Issue Date:	2022-05-10	<b>CEN-CLC/FGQT N194</b>
Deadline:	n/a	Supersedes: -
Status:	<input type="text"/>

TITLE                    **Functional Description of Control Highway**  
PROJECT                FGQT Roadmap  
REFERRING TO        Roadmap draft, N020i2  
SOURCE                Rob F.M. van den Brink (Delft Circuits, The Netherlands),  
                              [Rob.vandenBrink@Delft-Circuits.com](mailto:Rob.vandenBrink@Delft-Circuits.com)

We propose to replace all text in the present annex E, as currently collected in section E.6, by all the text below:

**Figure [E.6.1] An example of a control highway applicable to a particular transmon architecture.**

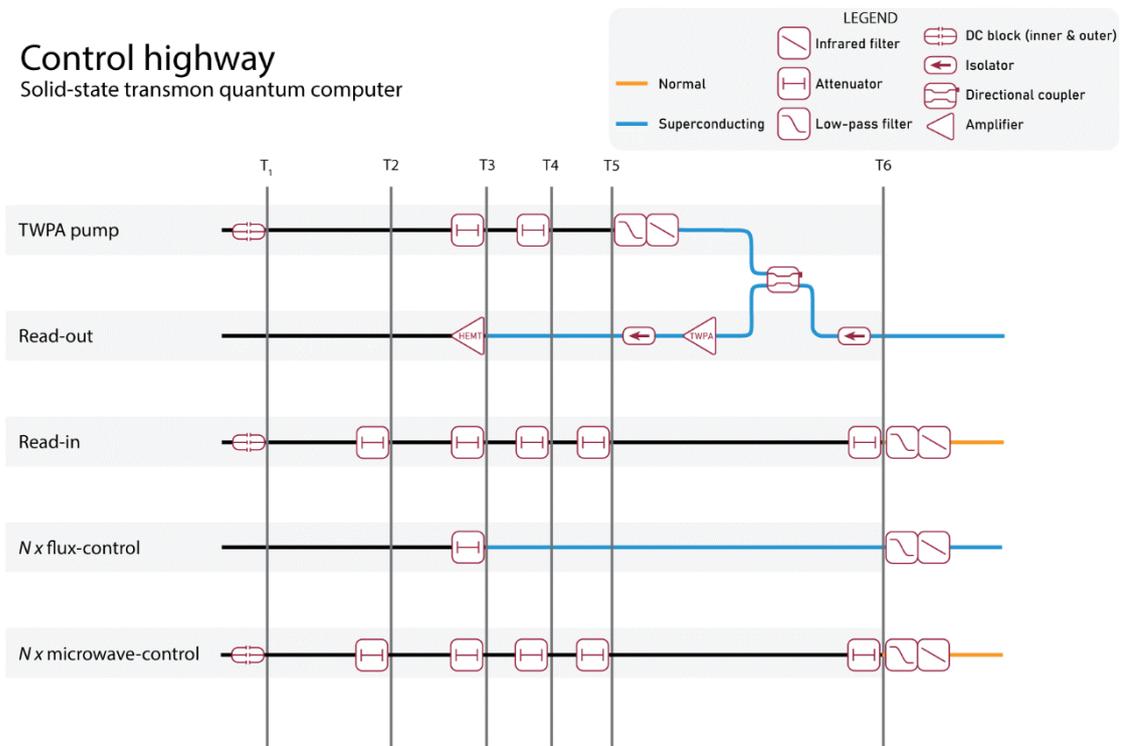
Figure [E.6.1] shows an *example* of a possible control highway dedicated to a *transmon* quantum computer. The I/O channels of *spin-qubit* quantum computers may be different, but this example alone may be sufficient to get basic understanding of various functional requirements for future standardisation.

In this example, the I/O of each qubit is handled via three channels: one for microwave control signals, another one for flux control and a third one for read-out. The response signals of two or more qubits may share a common read-out channel to reduce the overall number of channels. Travelling wave amplifiers may be used for amplifying these response signals, and the need an extra TWPA pump channel for powering. As such, a 50 qubit transmon quantum computer may have 102 or more I/O channels.
